BIG TOP EVENTS
BREESE STEVENS FIELD
MADISON, WI

PHASE
PRE-DESIGN -
SCOPE REVIEW

SHEET
A201
FIRST FLOOR PLAN
AND SECTIONS

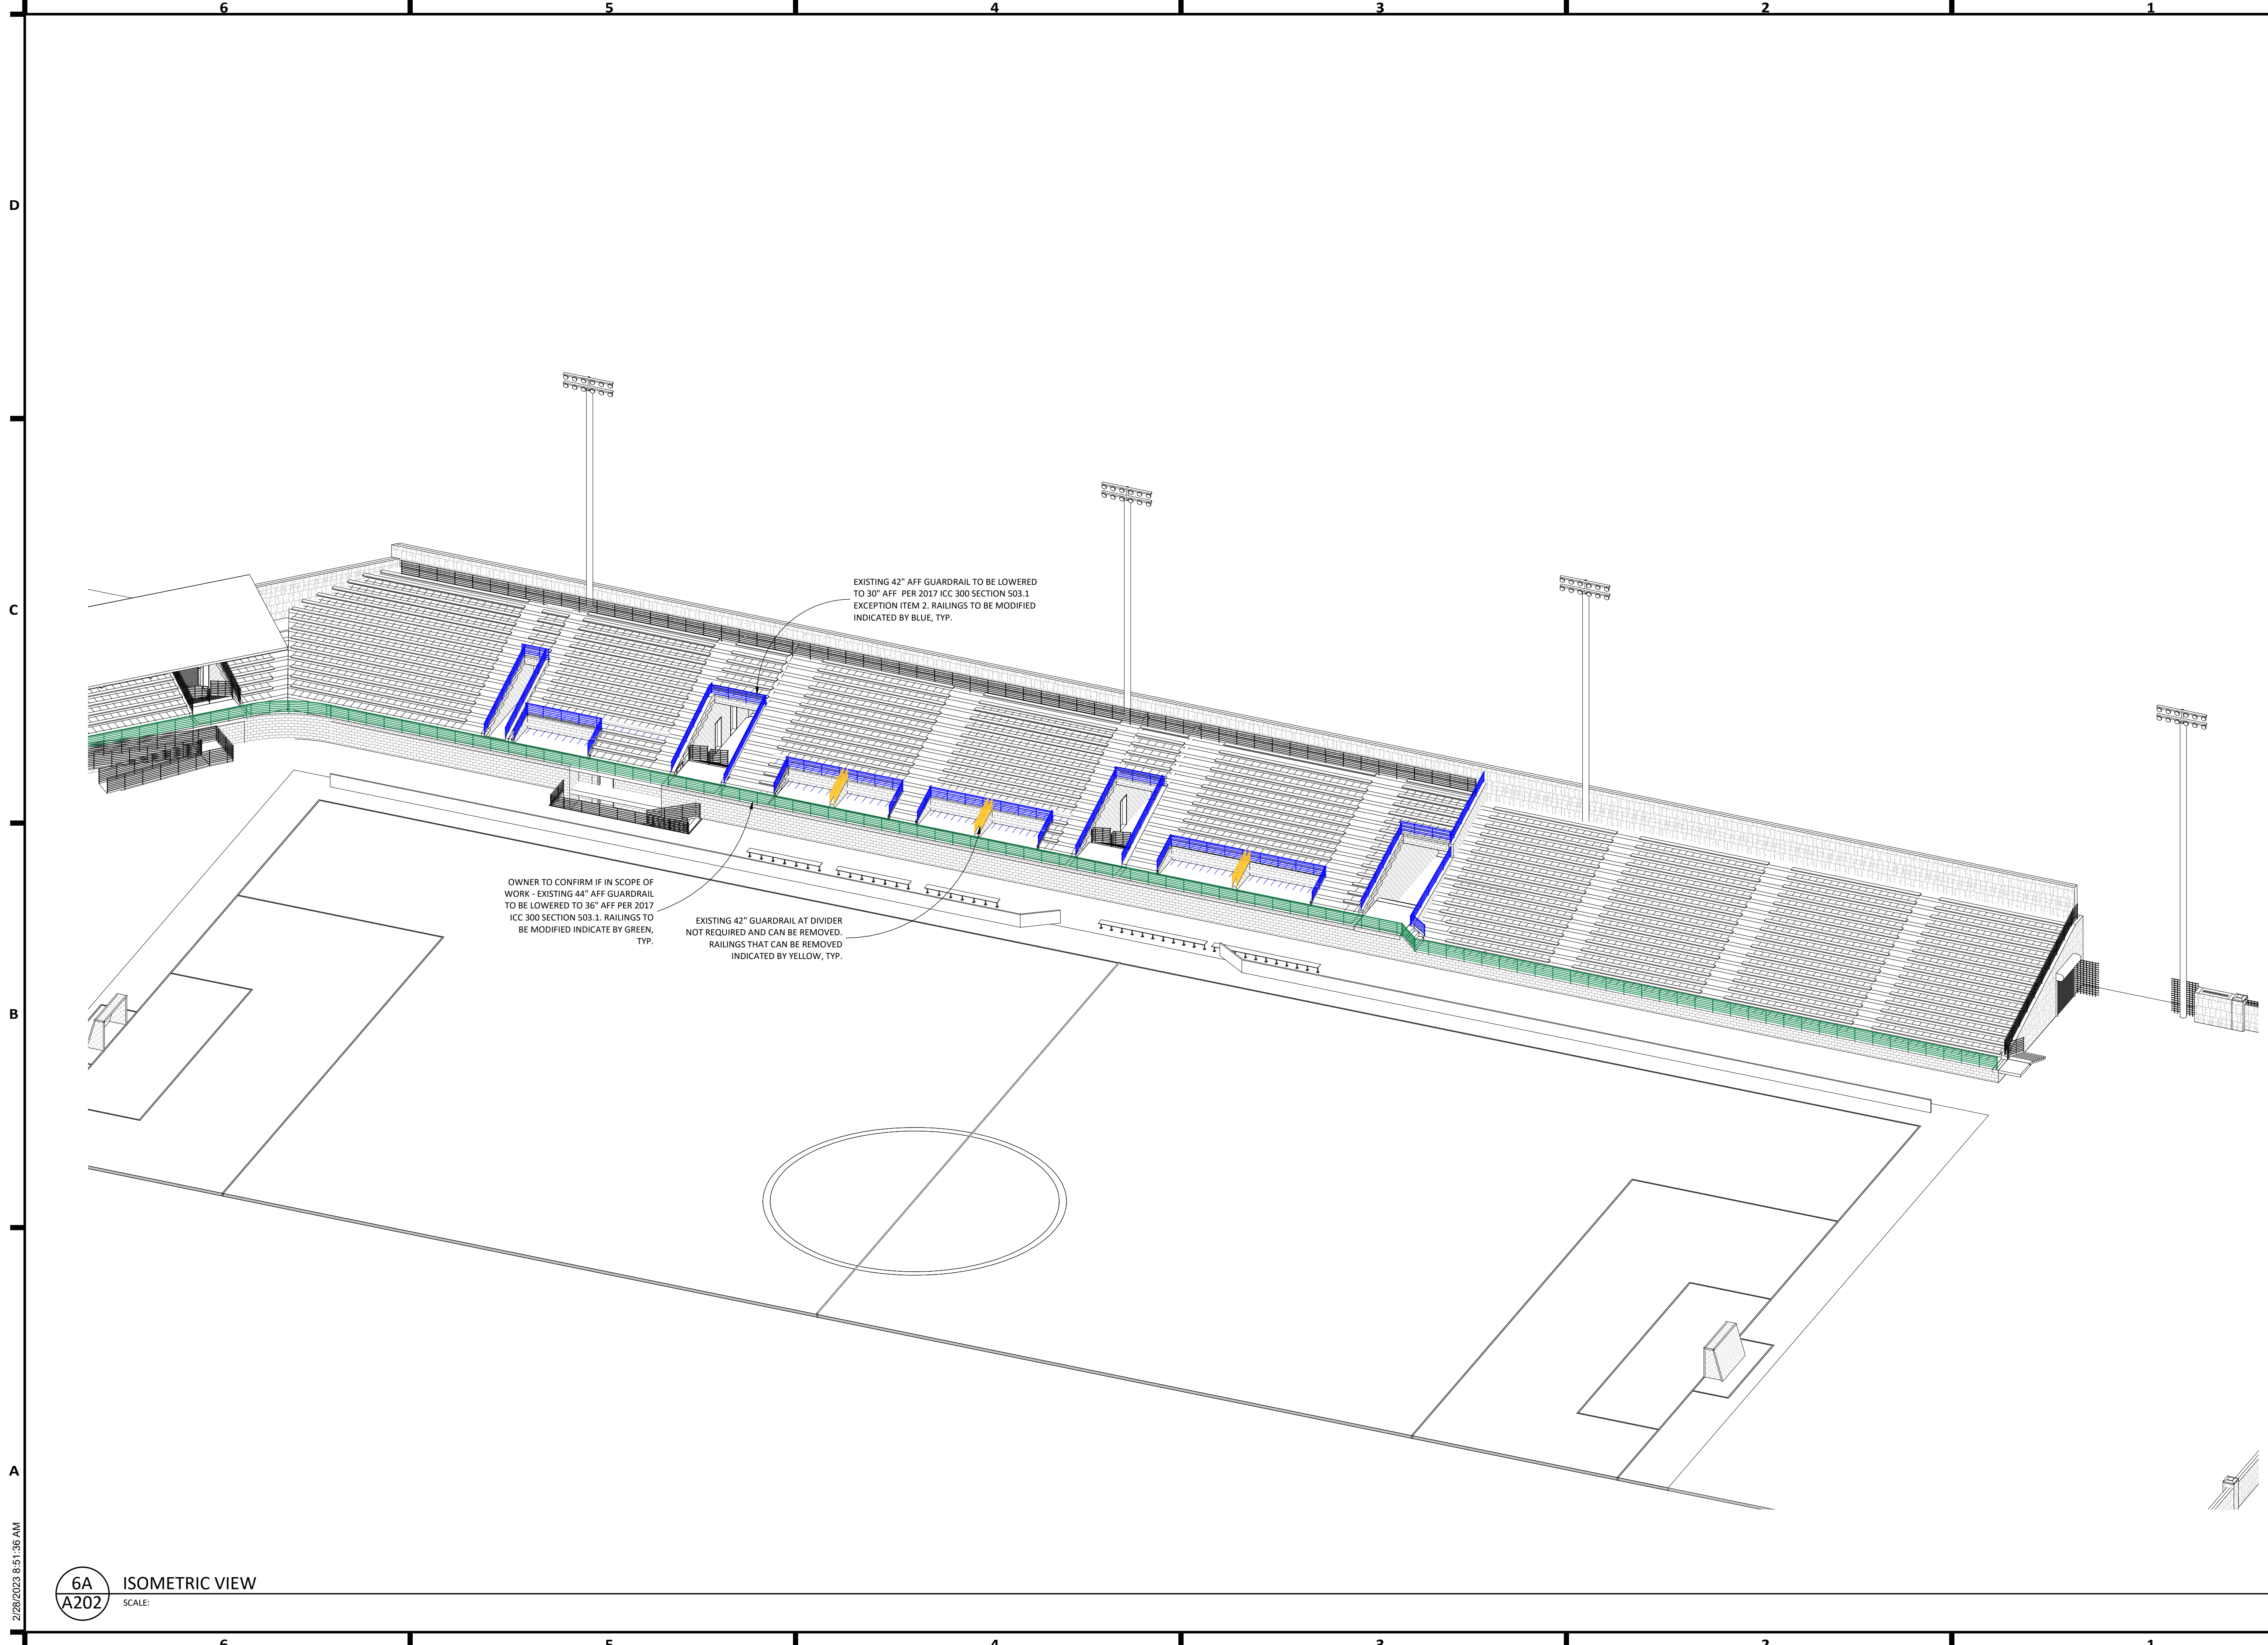
EXISTING 42" AFF GUARDRAIL TO BE LOWERED TO 30" AFF PER 2017 ICC 300 SECTION 503.1 EXCEPT ITEM 2. RAILINGS TO BE MODIFIED INDICATED BY BLUE, TYP.

OWNER TO CONFIRM IF IN SCOPE OF WORK - EXISTING 44" AFF GUARDRAIL TO BE LOWERED TO 36" AFF PER 2017 ICC 300 SECTION 503.1. RAILINGS TO BE MODIFIED INDICATE BY GREEN, TYP.

EXISTING 42" GUARDRAIL AT DIVIDER NOT REQUIRED AND CAN BE REMOVED. RAILINGS THAT CAN BE REMOVED INDICATED BY YELLOW, TYP.
